**Re: PROPOSED CITY OF RED BAY TRUNK LINE UPGRADE PROJECT
PHASE 1 – CONTRACT 4
CWSRF PROJECT NO. CS010833-03**

ADDENDUM NO. 3

SEWAGE DISPOSAL BOARD
 OF THE CITY OF
RED BAY, ALABAMA
 PROPOSED CITY OF RED BAY
 SANITARY SEWER TRUNK LINE
 UPGRADE PROJECT
PHASE I - CONTRACT 4
 CWSRF NO. CS010833-03
**EXISTING FLOW
 SPLITTER BOX
 MODIFICATIONS**

Utility Engineering Consultants, LLC <small>130 Southcrest Drive Suite 100 Homewood, Alabama 35209</small>		DESIGNED	DRAWN	SCALE	DATE
		RAH	CBR	AS NOTED	DEC., 2020
		APPROVED	REFERENCE	JOB NO.	
			C002ADD3.DGN	RB20_051	
SHEET		6	OF		8

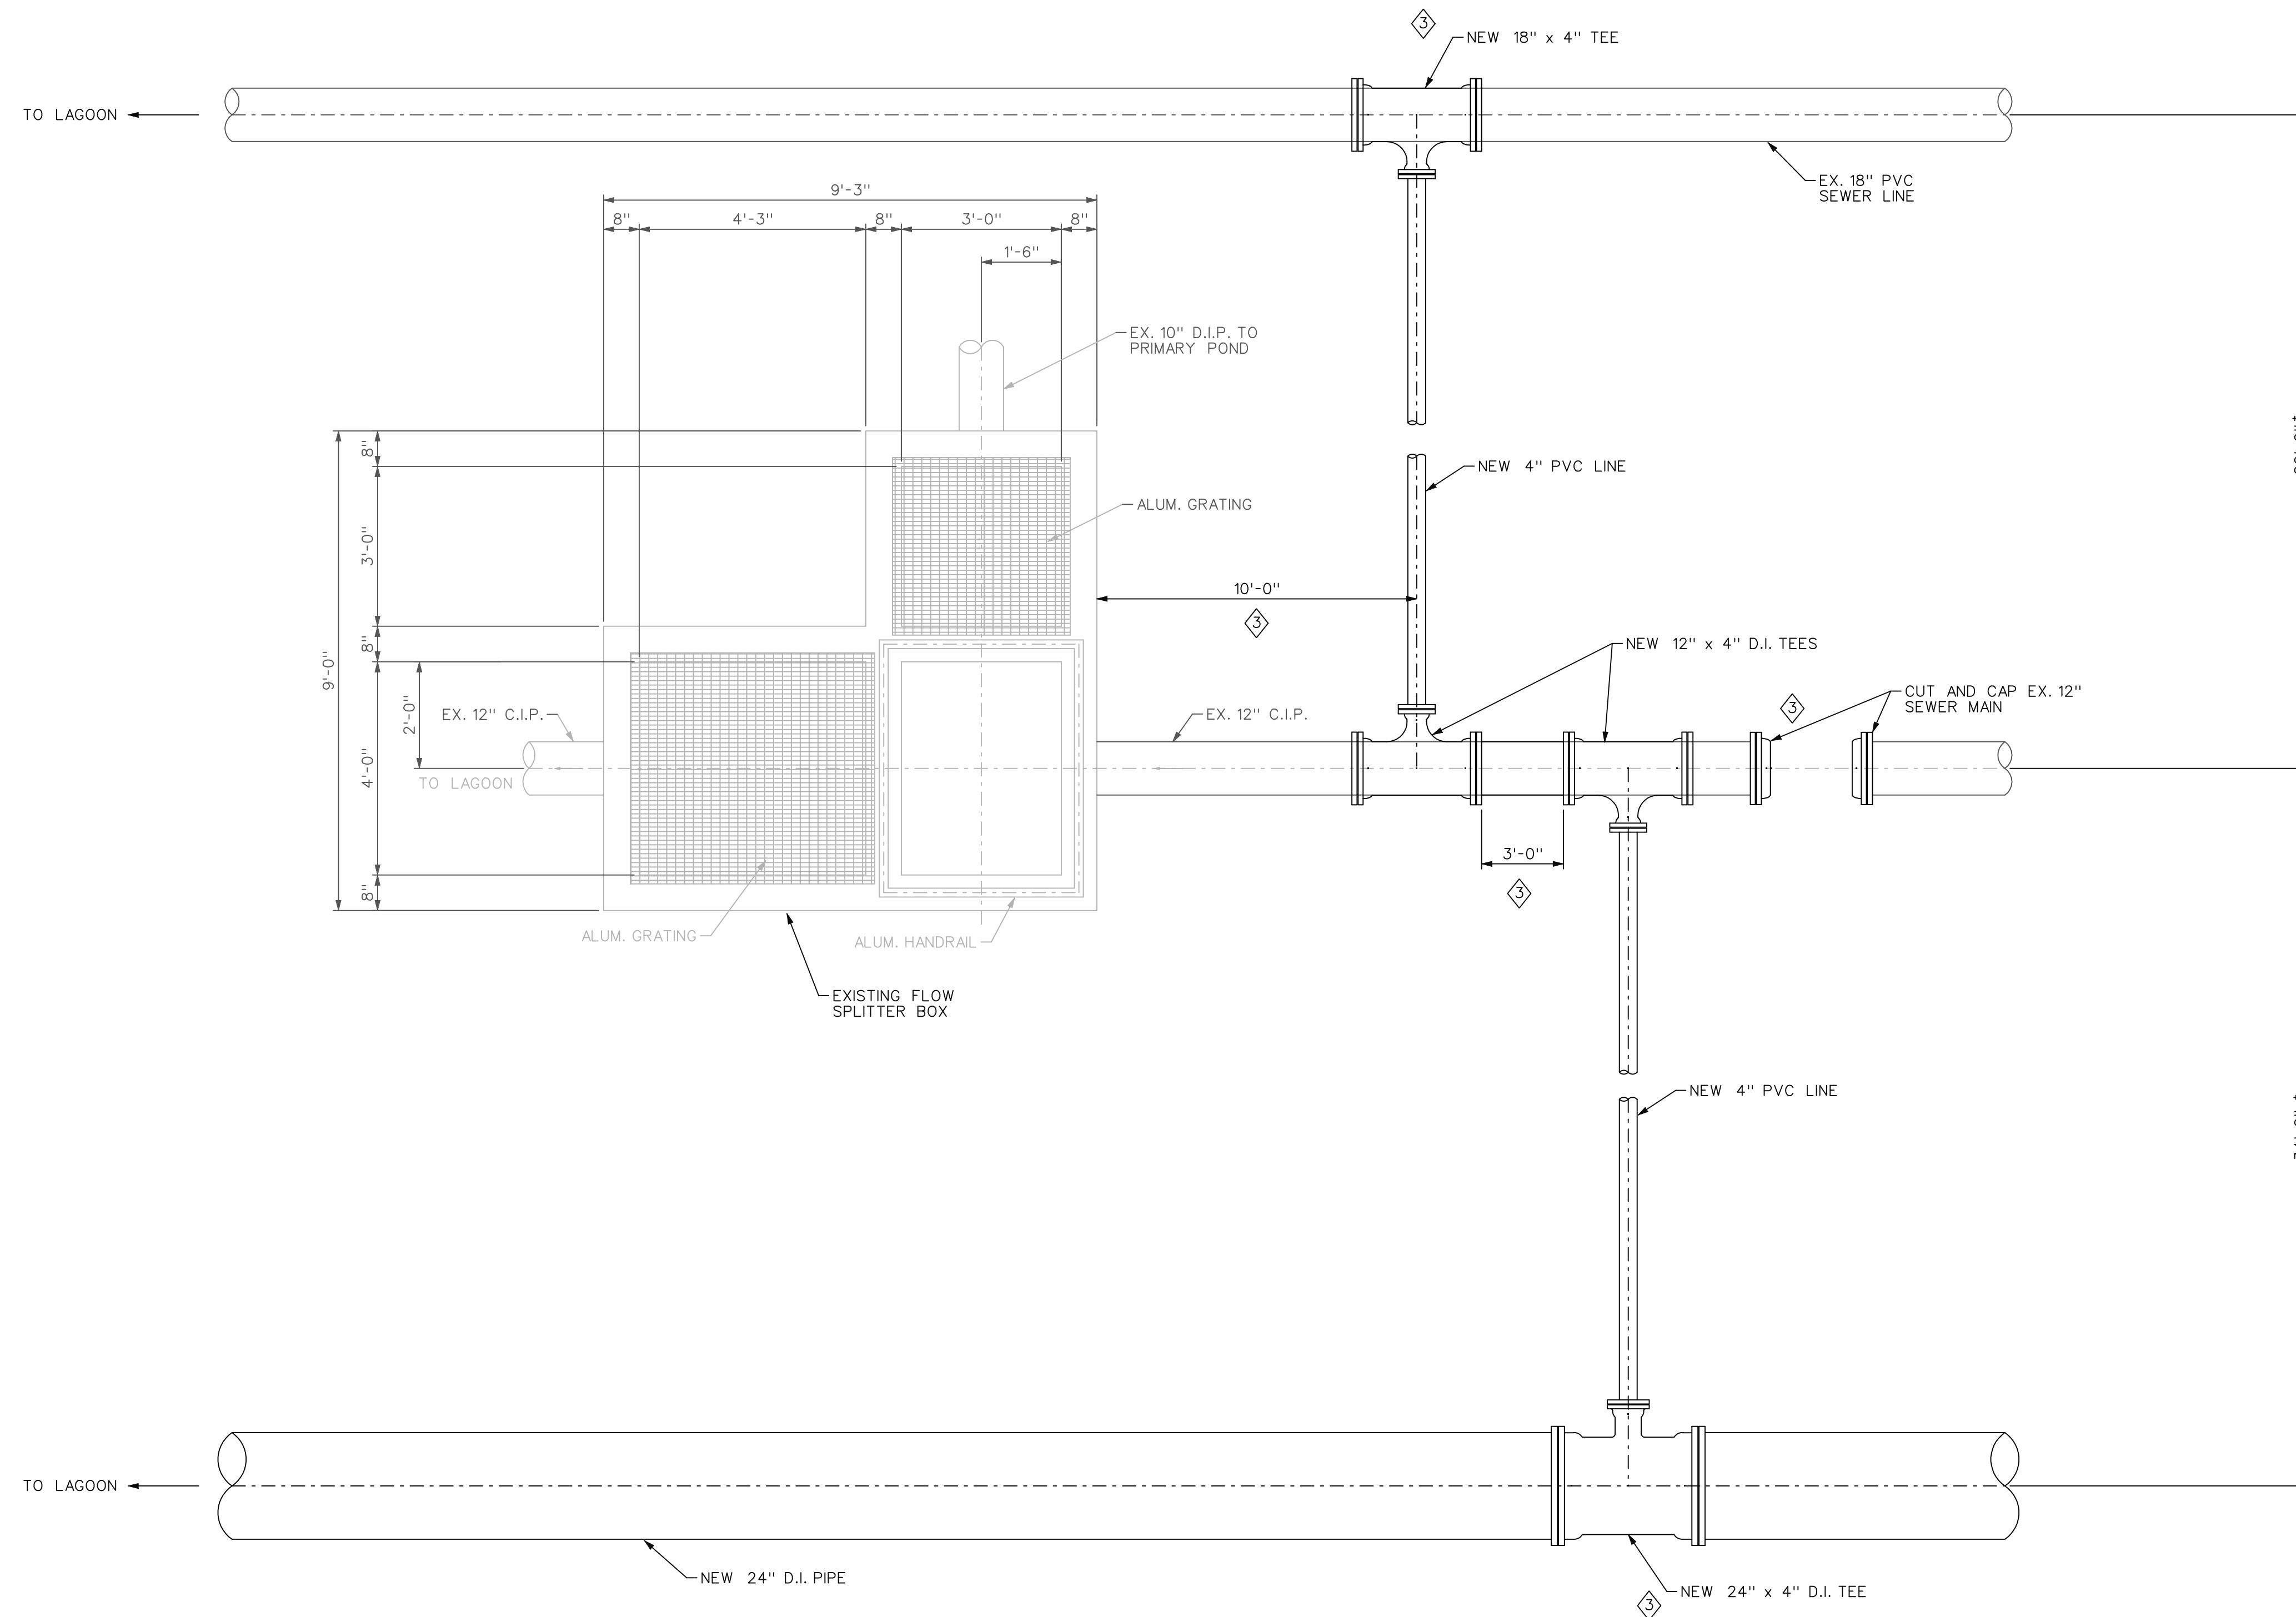
Sheet 6 of 8 – shall be reissued with the attached Sheet 6 of 8. Sheet 6 of 8 reflect tees at the connection points along the new and existing trunk lines. Saddles and inserta -tees are acceptable connection methods.
